HOWARD UNIVERSITY

**SUBJECT: AMEND LICENSE 08-00386-19
TO REMOVE RADIOACTIVE WASTE
STORAGE FACILITY COLLEGE
STREET 510 – ADDITIONAL
INFORMATION REQUESTED 6/18/12**

Close-Out Survey Report for Radioactive Waste Storage Facility 510 College Street

Figure 1 Diagram of 510 College Street

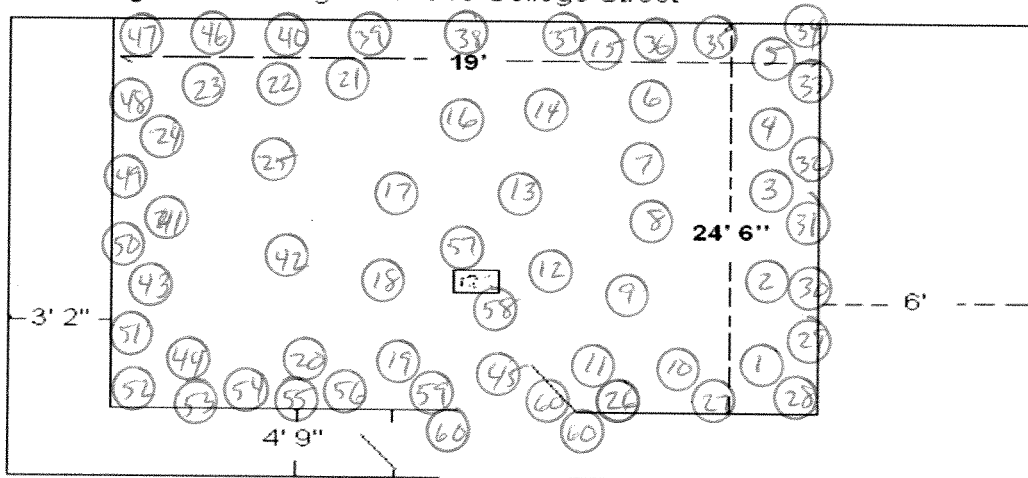
- a. Please explain what the actual dimensions of the room are, and explain what the dimensions in Figure 1 refer to, if they are not the dimensions of the waste storage area.

- b. Please use diagrams that show the dimensions of the room more accurately, with the location of survey points.

We re-measured the room area inside the waste facility. The actual dimension is about 24.5 ft. by 19 ft. (~465.5 ft. ²).

Please see attached
